Informal document **GRSP-55-42**
(55th GRSP, 19-23 May 2014,
agenda item 21)

UN Frontal Impact Requirements

OICA position

Margins during the vehicle development

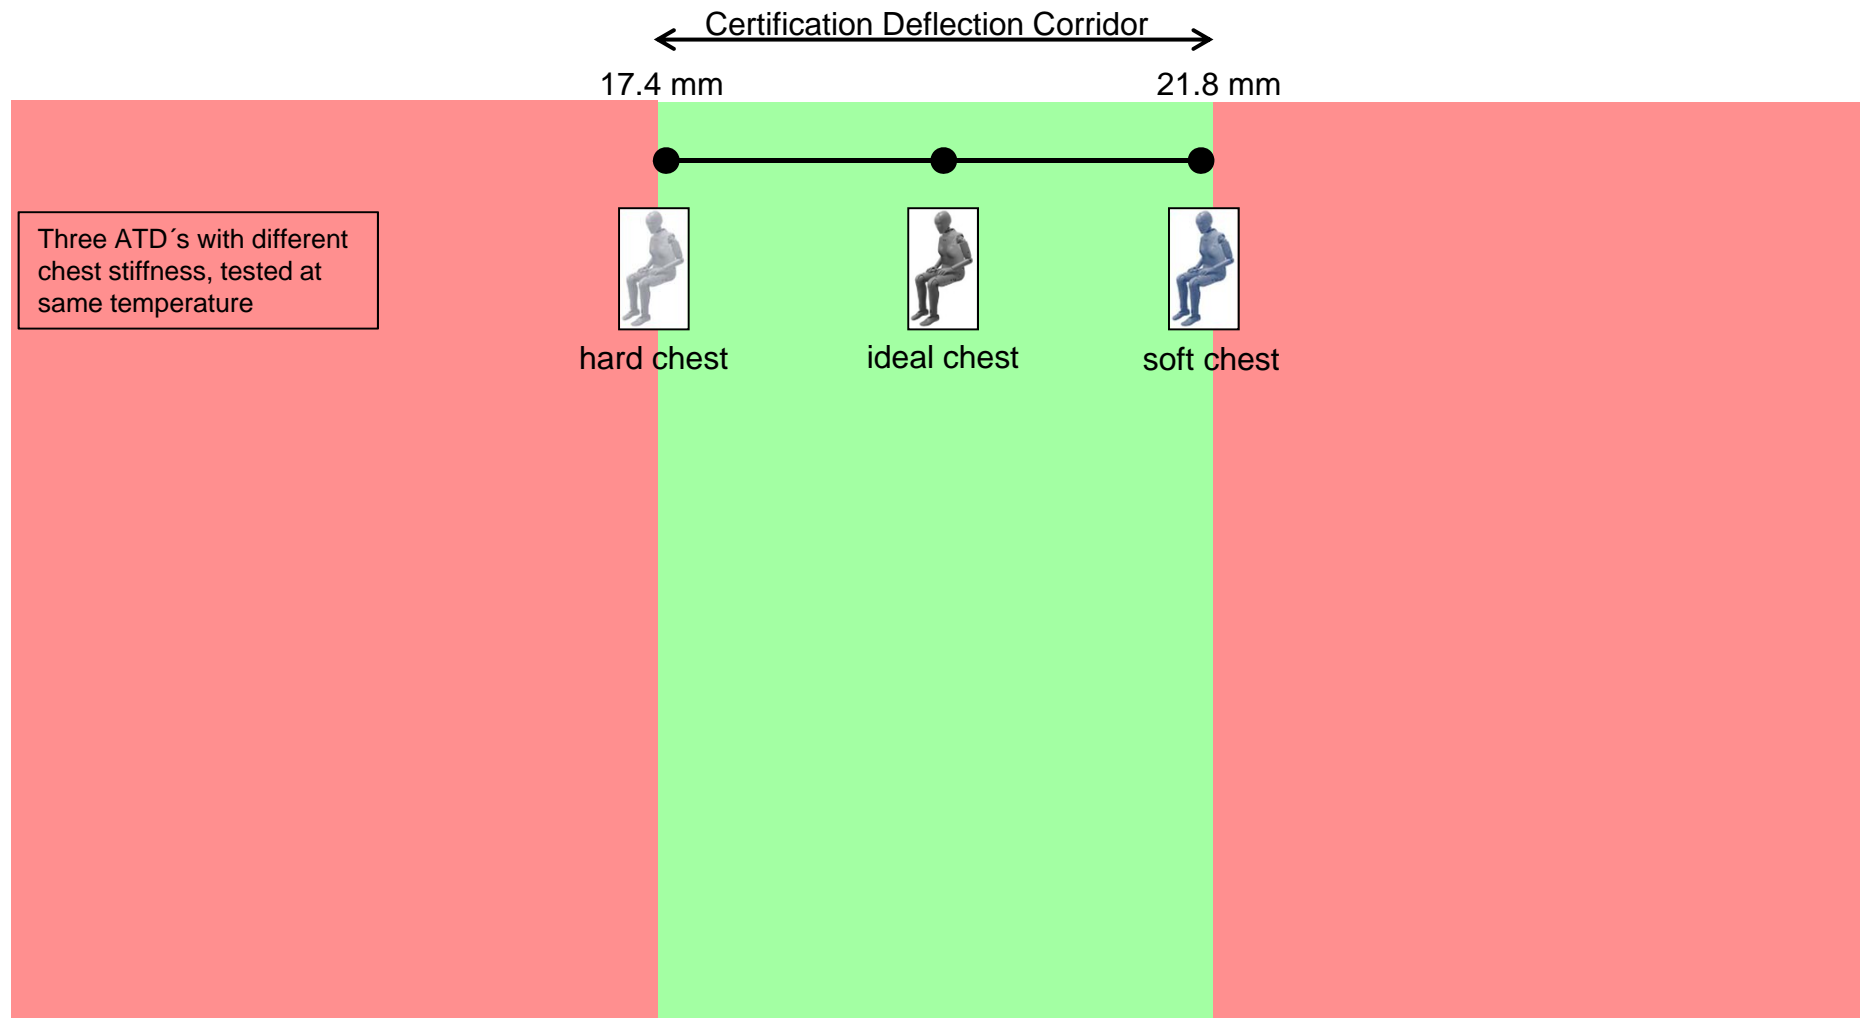
- OEM internal thresholds are lower than thresholds asked from Regulations to consider tolerances in...
 - Test tools
 - Test setup
 - Vehicle production

- **There is a 8,4 mm tolerance in the chest deflection coming from the certification of the 5%*f* chest**
- **This would lead to an internal threshold of < 34 mm in the case of a legislative requirement for 42mm**
